U.S. NUCLEAR REGULATORY COMMISSION
REGION I

Report No. 50-293/85-22

Facility Name: Pilgrim Nuclear Power Station

Inspection Summary: Inspection on August 19-23, 1985 (Report No. 50-293/85-13)

Figure 1
Hot Shop Ventilation
Flow Path ①

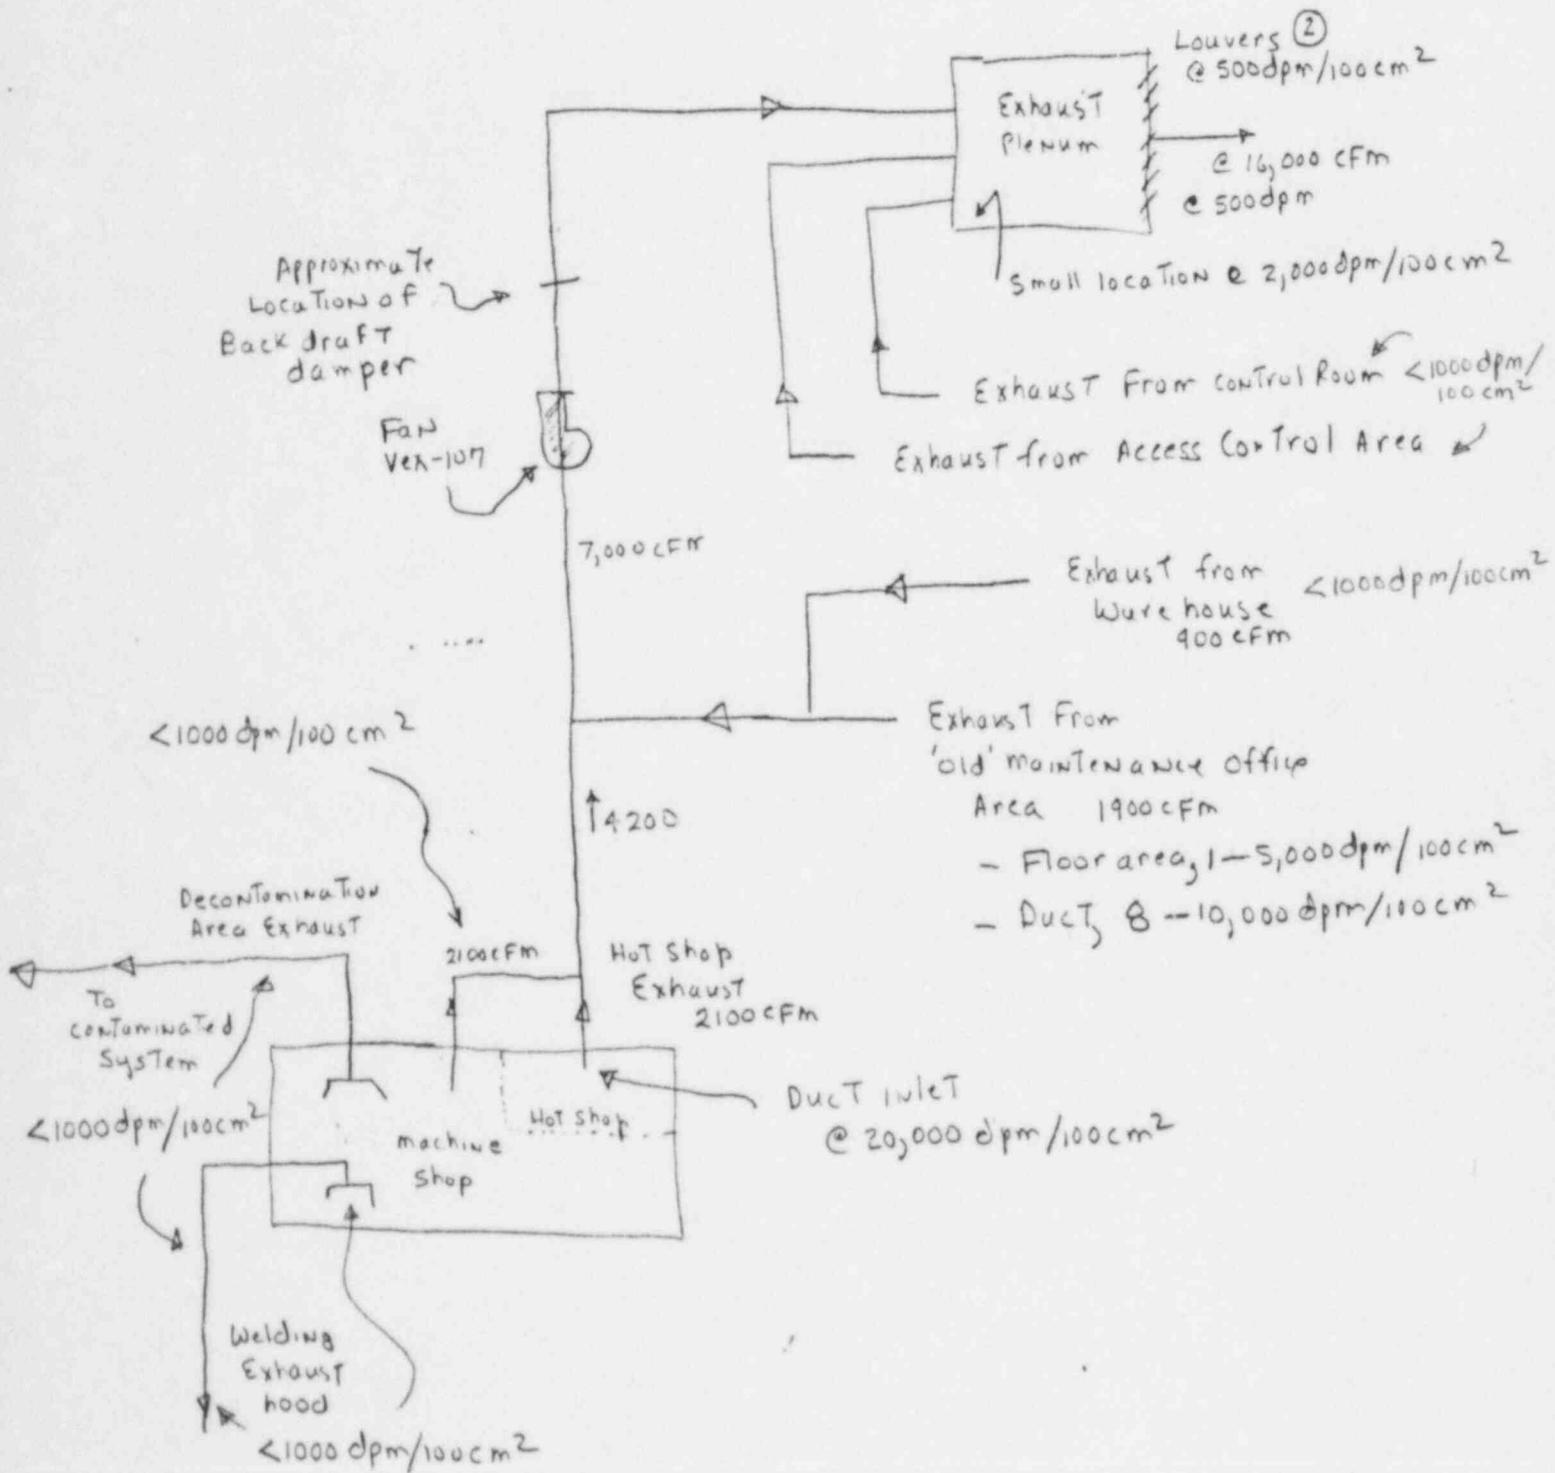
On July 30, 1985, a contamination survey of the "Old Maintenance Office" floor area identified low level floor contamination (1000-2000 disintegration per minute per 100 centimeters squared [dpm/100 cm²]). An investigation as to the source of the contamination indicated it apparently was emanating from exhaust duct work in the area. Further investigation indicated the local exhaust duct work tied into exhaust duct work from the "Hot" Machine Shop. This former duct work eventually exhausted its contents to the atmosphere outside the Turbine building. (See Figure 1)

- The licensee estimated that about 50 millicuries of a mixture of cobalt-60 and cesium-137 may have been released. The licensee's estimates (using various particle sizes) ranged from 2×10^{-5} millicuries to about 3.2 curies. However, the licensee's evaluation did not provide sufficient information to demonstrate whether he had or had not complied with the average offsite concentration values of 10 CFR 20.106 or, 2) complied with the average onsite concentration values of 10 CFR 20.103.

- The cause of the unmonitored release path was due to insufficient review when this area of the station was converted to a "Hot" machine shop.
- Licensee Procedure 3.02, "Preparation, Review Verification, Approval and Revision of Design Documents for Plant Design Changes", dated December 10, 1984, provides guidance for review of design changes by radiological control personnel. However, inspector review of this procedure indicated the procedure does not appear to clearly show how a similar event could not occur. i.e., (Conversion of a normally clean room to a contaminated area and subsequent offsite release.)

Based on the above review, the following matters are unresolved and will be reviewed during a future inspection: (50-203/85-22-05)

- licensee evaluation of offsite releases with respect to 10 CFR 20.106,
- licensee evaluation of onsite releases with respect to 10 CFR 20.103,
- licensee close-out of applicable Radiological Occurrence Reports and Failure and Malfunction Reports,
- licensee completion of a safety evaluation for further operation of "Hot Shop" exhaust ventilation (including need to monitor this release point),
- source of contamination of duct work in Control Room Corridor and HP Count Room,
- design change methodology to preclude recurrence, and
- update of Final Safety Analysis Report to reflect actual conditions of "Hot Shop" area.

Figure 2

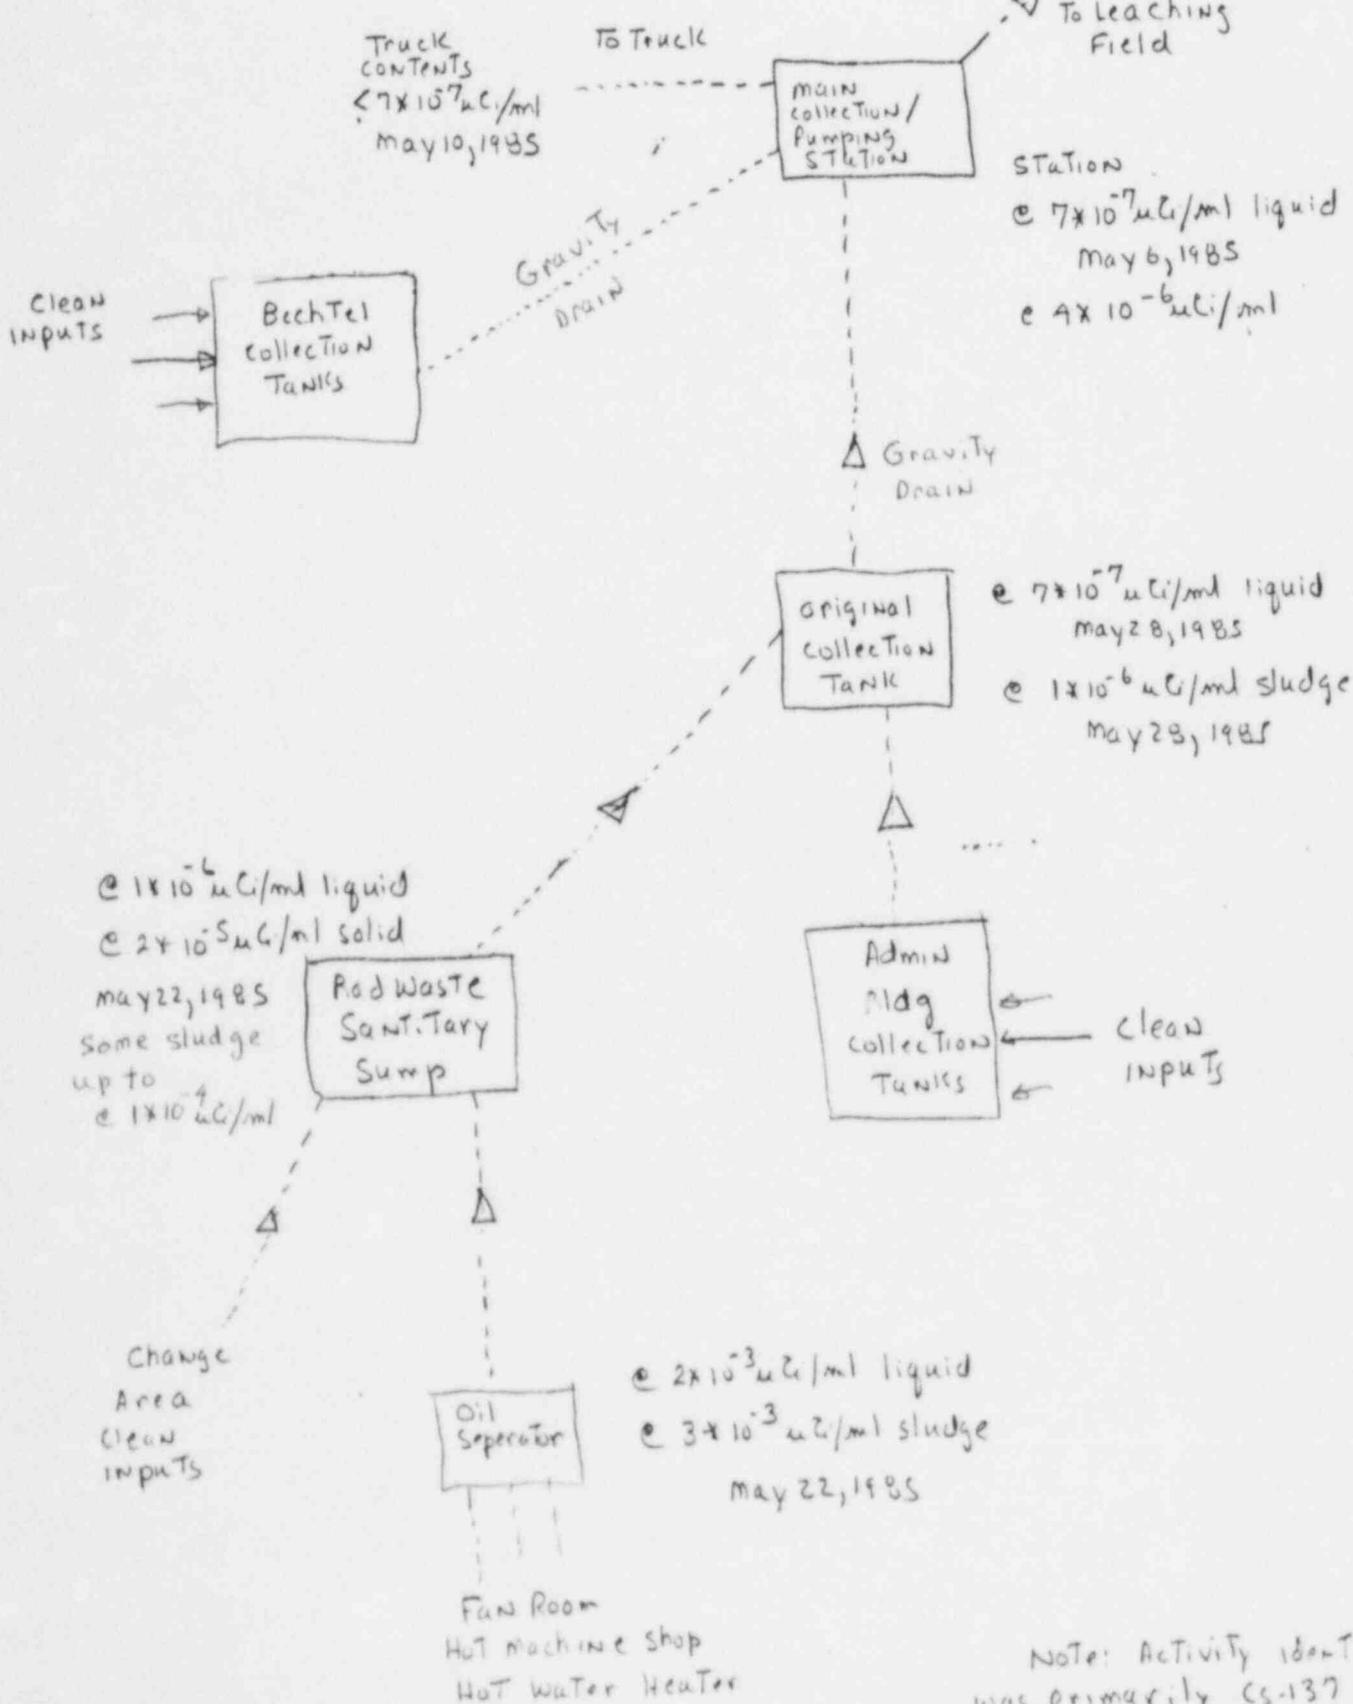
On May 3, 1985, a drain in the licensee's "Hot Machine Shop" (23' elevation) was identified as apparently backing up. A Radiological Occurrence Report was written at that time. Since this drain was plugged and located in a contaminated area, an investigation was initiated to determine the ultimate disposal point of the drain. The licensee's investigation indicated that liquid in the drain may be directed to the Main Sewage Pumping Station. Since the effluent from this pumping station is directed to an onsite leaching field and the pumping station effluent is periodically pumped out and sent to the Plymouth Sewage Disposal facility, the Main Pumping Station potentially represented an unmonitored effluent release path. The sewage flow path is shown in Figure 2. The licensee notified the resident inspector of this finding on May 10, 1985. This matter was reviewed in part during inspection 50-293/85-13. (Conducted May 20-24, 1985). At that time it was determined that the licensee had failed to implement a noncontaminated system sampling program consistent with the requirements of IE Bulletin 80-10, "Contamination of Nonradioactive System and Resulting Potential for Unmonitored/Uncontrolled Release to the Environment." The NRC took enforcement action on this matter at that time. The licensee initiated a comprehensive review of the facility design with respect to IE Bulletin 80-10 in order to identify other problems in this area. The licensee took the following actions when the backed up drain was identified:

- The licensee initiated timely action to:
 1. identify the final release point of the Hot Machine Shop drains;
 2. prevent release of the material offsite;
 3. isolate the contaminated inputs into the sewage system;
 4. sample and analyze the hold-up and disposal points of the sewage;
 5. take long term corrective action to review facility design to identify any further unmonitored release points.
- Concentrations of radioactive material identified in final onsite storage transfer tanks (i.e. Main Sewage Pumping Station) were at concentrations of less than 10% of offsite average allowable concentration values.
- No releases in excess of 10 CFR 20.106 or 10 CFR 20.303 was identified.
- The licensee initiated a routine sampling and analyses program for sewage to be transferred offsite.
- The licensee included the Plymouth landfill in his environmental monitoring program.
